OBJECTION TO App. No. 2017/2471/P – 15 Lyndhurst Gardens NW3 From: THE HEATH AND HAMPSTEAD SOCIETY

Objection to 2017/2471/P planning application for 15 Lyndhurst Terrace

Big opportunity to reveal ground water conditions under heavy rainfall missed: lack of continuous monitoring

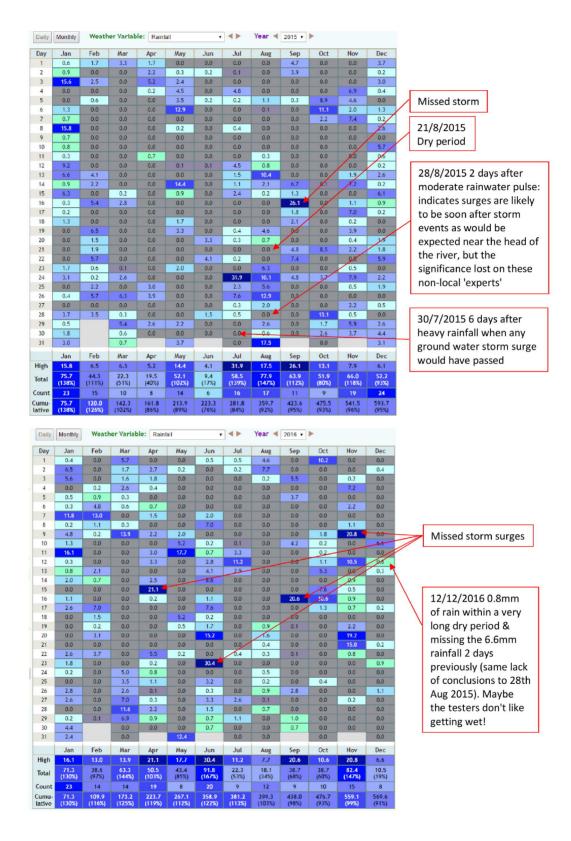
Looking at rainfall data for these dates (see historic data tables from nw3 weather - http://nw3weather.co.uk/wxdataday.php - below) it can be seen that these studies are woefully inadequate. Not being continuous monitoring as they should have been, the days when the boreholes were looked at generally occurred during periods of dry weather, completely missing any days of heavy rainfall when surging could be monitored.

22/2/2017 Long dry period

As with 2015/6278/P please would the independent examiners for this application demand that adequate testing be done prior to planning permission to ensure that appropriate construction techniques are used to match the actual ground and water conditions, to prevent catastrophes during construction, and to protect neighbours *and trees* upstream and downstream from the effects of both damming up and constraining the local ground water. "Know what the ground does."
